BC HYDRO F2020–F2021 REVENUE REQUIREMENTS EXHIBIT A-15

**Re: British Columbia Hydro and Power Authority – F2020–F2021 Revenue Requirements Application –
Project No. 1598990 – Information Request No. 3**

INFORMATION REQUEST NO. 3 TO BRITISH COLUMBIA HYDRO AND POWER AUTHORITY

**296.0 Reference: REGULATORY ACCOUNTS
Exhibit B-5, BCUC IR 148.1, 148.3, 148.4; Exhibit B-11, Figure 1, p. 1
Deferral Account Rate Rider (DARR)**

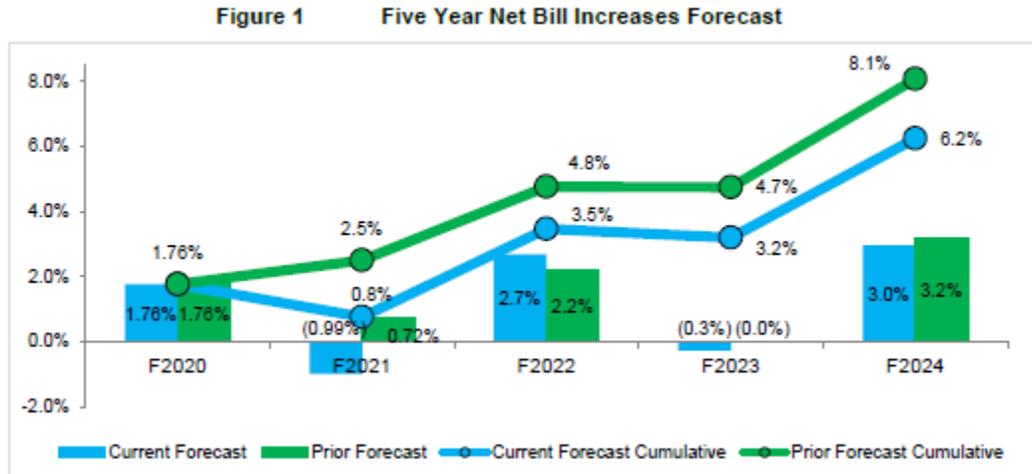
- 296.3 Please update Figure 1 to include the five-year net bill impact under the scenario that the BCUC does not approve the requests described on page 7-26 of the Application and directs BC Hydro in the current Test Period to return to the F2009-F2010 DARR Mechanism. Please also identify the amount of the DARR revenue, the revenue shortfall and the DARR percentage applicable for each fiscal year.

- 296.4 Please update Figure 1 to include the five-year net bill impact under the scenario that the BCUC does not approve the requests described on page 7-26 of the Application and directs BC Hydro in the current Test Period to return to the F2009-F2010 DARR Mechanism but modified to use:

- 296.5 Please provide similar figures as in the response to the two preceding IRs (i.e. IR 296.3 and 296.4), but with the five-year rate impact instead of the net bill impact.
